SARA reference: 2604-51886 SRA
Council reference: CA 2025_5880/1
Applicant reference: 2025-09-82 - Seymour Group

Changed referral agency response—with conditions

Description:	Development permit	Reconfiguring a lot (1 lot into 40 lots and common property)
	Preliminary approval	Material change of use for use rights consistent with the low-medium density residential zone and to vary the effect of the planning scheme by amending the table of assessment for short term accommodation

Subdivision of Land Parcel SP150468 at 71-85 Port Douglas Road, Port Douglas

DRAWING TITLE	PROJECT NUMBER	DRAWING NUMBER	REVISION
PRELIMINARY STORMWATER DRAINAGE CATCHMENT PLAN	BE25041-001	DA400	2

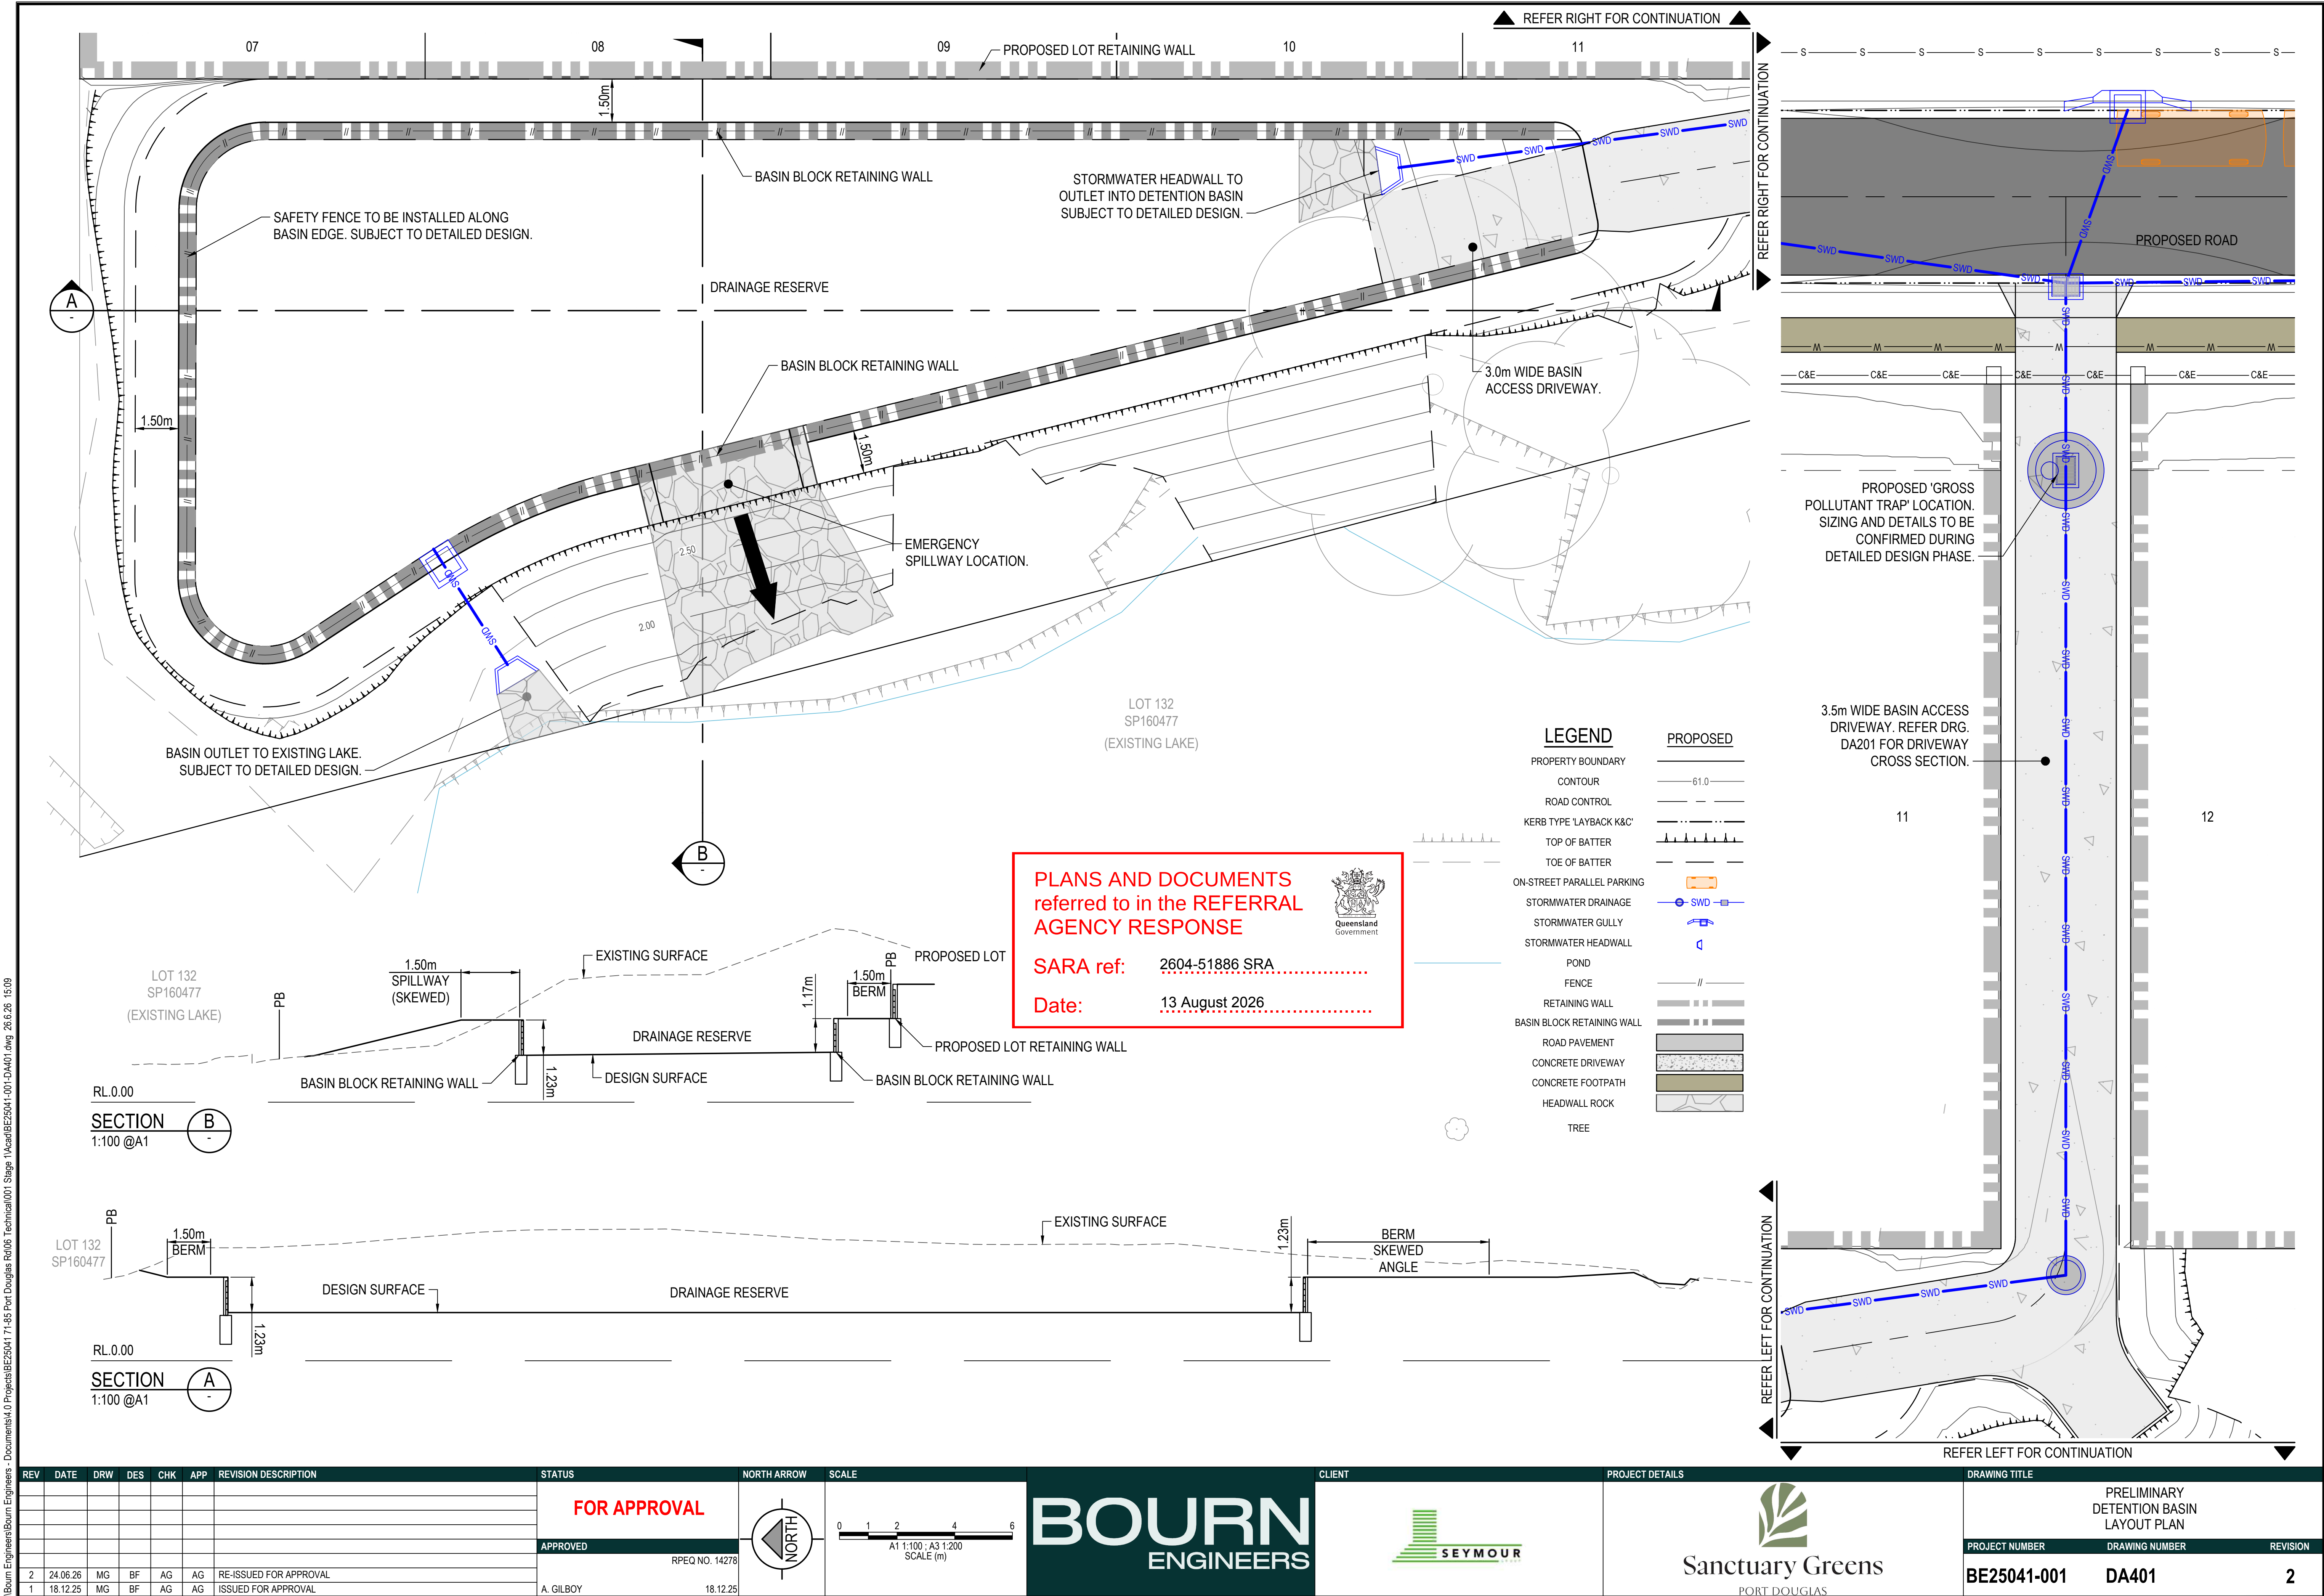
1.	Stormwater infrastructure works must be undertaken generally in accordance with the following plans: (a) Preliminary Stormwater Drainage Catchment Plan prepared by Bourn Engineers, dated 24.06.26, Drawing DA400, Revision 2. (b) Preliminary Detention Basin Layout Plan prepared by Bourn Engineers, dated 24.06.26, Drawing DA401, Revision 2.	Prior to submitting the Plan of Survey to the local government for approval.

REV	DATE	DRW	DES	CHK	APP	REVISION DESCRIPTION	STATUS	NORTH ARROW	SCALE	CLIENT	PROJECT DETAILS	DRAWING TITLE
2	24.06.26	MG	BF	AG	AG	RE-ISSUED FOR APPROVAL	FOR APPROVAL					PRELIMINARY SITE ENTRANCE INTERSECTION FUNCTIONAL LAYOUT PLAN
1	16.12.25	MG	BF	AG	AG	ISSUED FOR APPROVAL	APPROVED

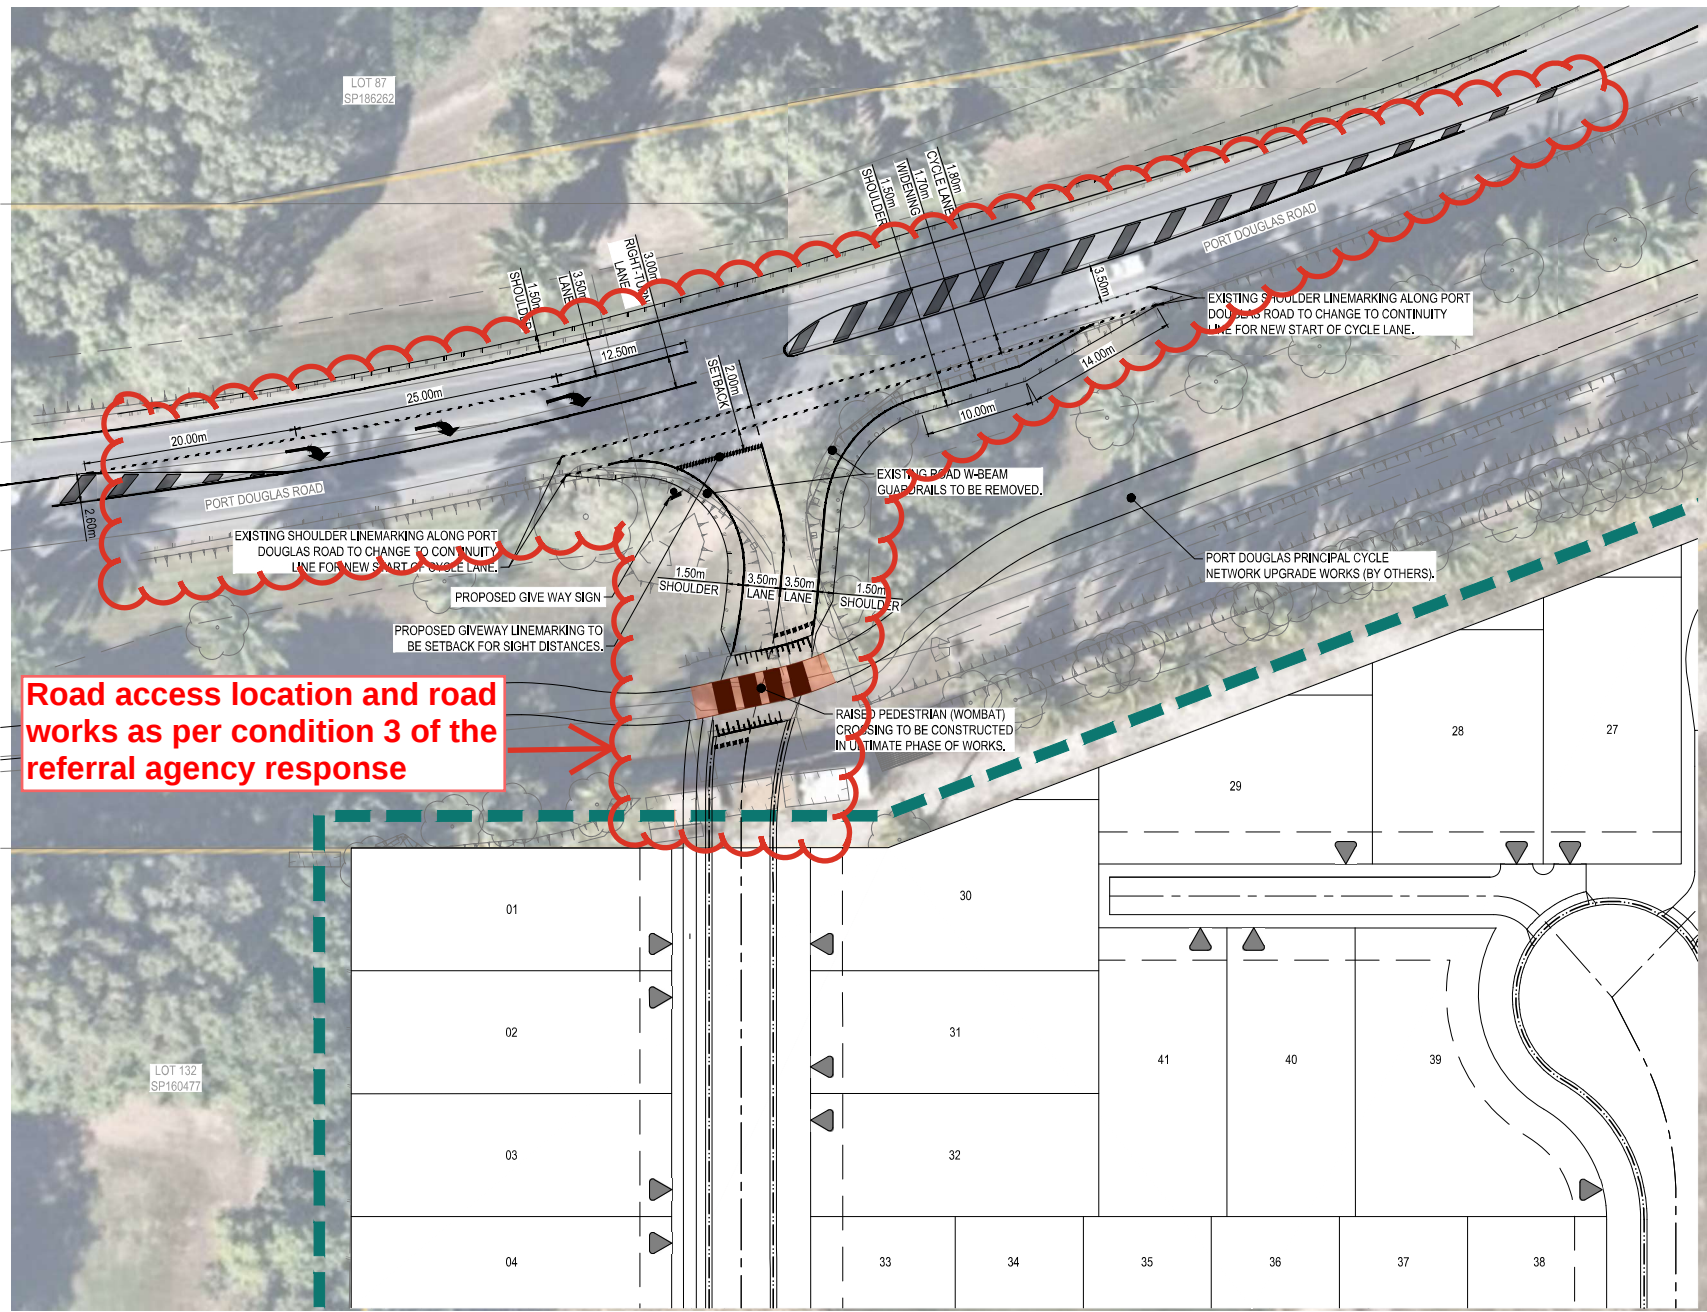
Road access location and road works as per condition 3 of the referral agency response

Amended in red by SARA on
13 August 2026

3.	(a) Road accesses are located generally in accordance with Preliminary Site Entrance Intersection Functional Layout Plan prepared by Bourn Engineers, dated 24.06.26, Reference DA500 and Revision 2, as amended in red by SARA. (b) Road access works including road lighting must be provided at the road access location referred to in part (a) of this condition	(a) At all times. (b) and (c): Prior to submitting the Plan of Survey to the local

comprising of: (i) a sealed channelised right-turn treatment with a short turn slot (CHR(S)); and (ii) a sealed Basic left-turn treatment (BAL). (c) Design and construct the road access works, referred to in part (b) of this condition, in accordance with: (i) Preliminary Site Entrance Intersection Functional Layout Plan prepared by Bourn Engineers, dated 24.06.26, Reference DA500 and Revision 2 (ii) Austroads Guide to Road Design Part 4A: Unsignalised and Signalised Intersections, June 2026 • Figure 7.2: Channelised right-turn treatment with a short turn slot (CHR(S)) on a two-lane rural road • Figure 8.2: Basic left-turn treatment (BAL) (iii) Department of Transport and Main Roads', Road Planning and Design Manual, 2nd edition • Volume 3 – Guide to Road Design, September 2025 • Volume 6 – Lighting, March 2021.	government for approval.
--	---	---------------------------------
